# RENESAS TECHNICAL UPDATE

Product Category	MPU&MCU	Document No.	TN-H8*-A326A/E	Rev.	1.00
Title	About the specification change of TPU and port 1			Information Category	
Applicable Product	H8/38086R Group H8/38076R Group	Lot No.	Reference Document	Technical Notification	
		All		H8/38086R Group Hardware manual (REJ09B0182-0200 Rev.2.00) H8/38076R Group Hardware manual (REJ09B0093-0300 Rev.3.00)

The specification of TPU and the port of the H8/38086R group and the H8/38076R group will be changed, Please refer to the following for details of the hardware manual.

Figure 12.10 Example of 0 Output/1 Output Operation

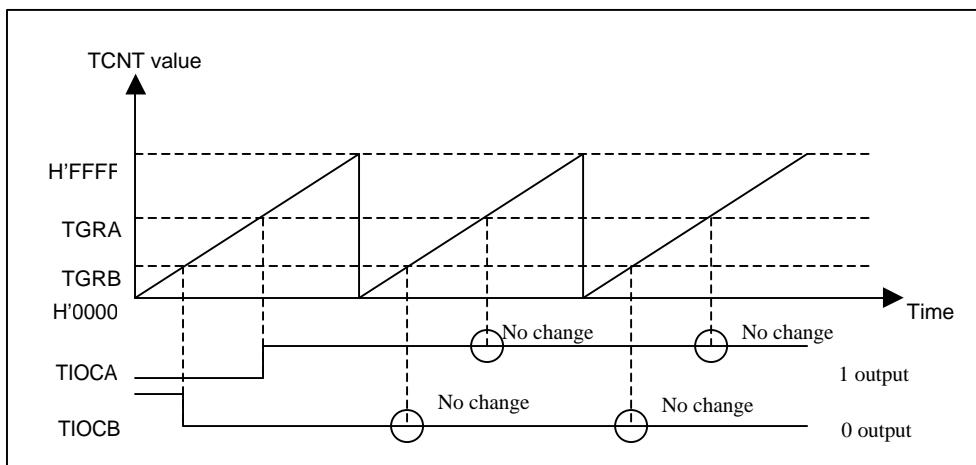
Figure 12.10 shows an example of 0 output/1 output.

In this example, TCNT has been designated as a free-running counter, and settings have been made such that 1 is output by compare match A, and 0 is output by compare match B. When the set level and the pin level match, the pin level does not change.

Figure 12.20 Example of PWM Mode Operation (2)

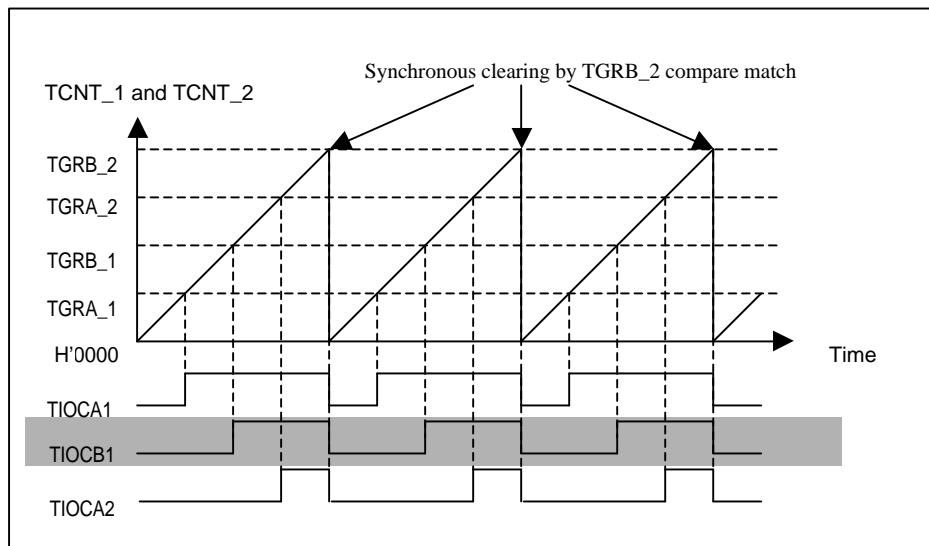
Figure 12.20 shows an example of PWM mode 2 operation. In this example, synchronous operation is designated for channels 1 and 2, TGRB\_1 compare match is set as the TCNT clearing source, and 0 is set for the initial output value and 1 for the output value of the other TGR registers (TGRA\_1, TGRB\_1, and TGRA\_2), outputting a 3-phase PWM waveform. In this case, the value set in TGRB\_1 is used as the cycle, and the values set in the other TGRs are used as the duty levels.

Figure 12.10 Example of 1 Output Operation

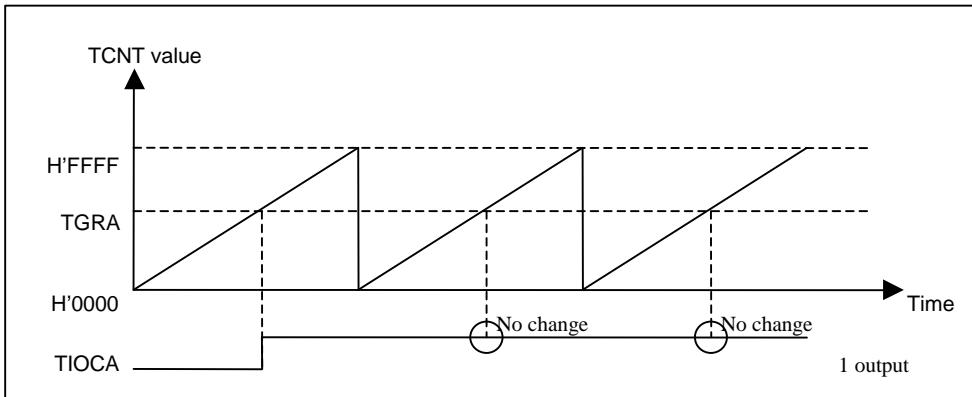
Figure 12.10 shows an example of 0 output/1 output

In this example, TCNT has been designated as a free-running counter, and setting the 1 is output by compare match A. When the set level and the pin level match, the pin level does not change.

Figure 12.20 Example of PWM Mode Operation (2)

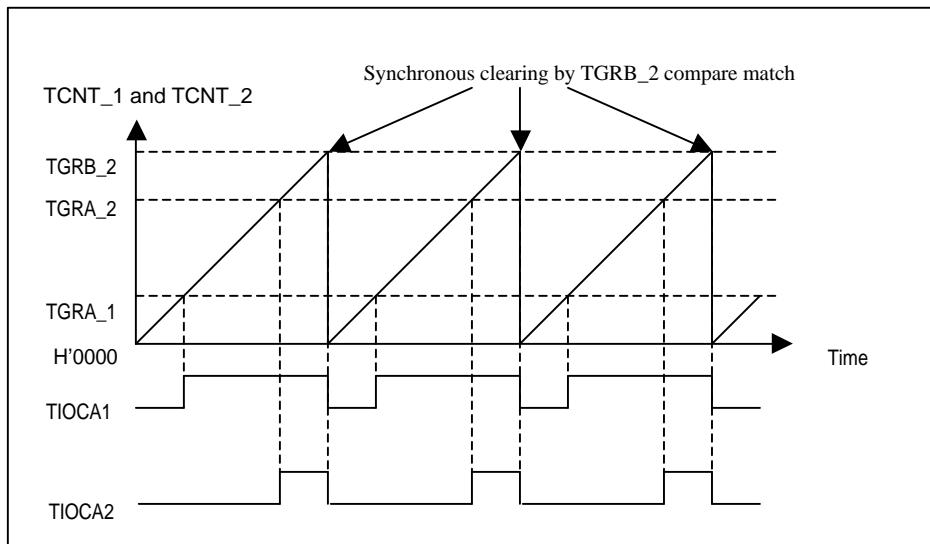
Figure 12.20 shows an example of PWM mode2 operation. In this example, synchronous operation is designated for channels 1 and 2, TGRB\_2 compare match is set as the TCNT clearing source, and 0 is set for the initial output value and 1 for the output value of the other TGR registers (TGRA\_1, and TGRA\_2), outputting a 2-phase PWM waveform.

In this case, the value set in TGRB\_2 is used as the cycle, and the values set in the other TGRs are used as the duty levels.
